Overview

Pinout Differences

Audio Return Channel

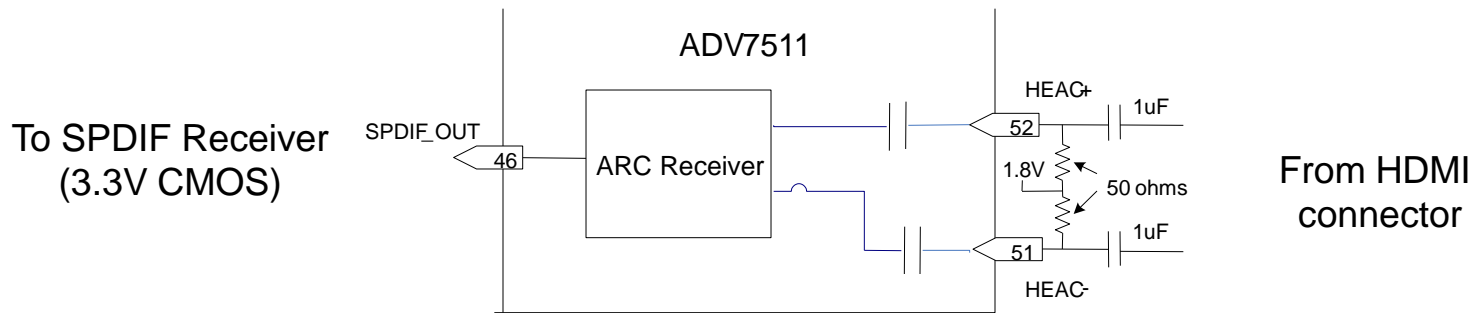
- ◆ ADV7511 adds the ARC function from HDMI 1.4a
- ◆ PCB Change
 - Add the following circuit to incorporate the ARC function in hardware
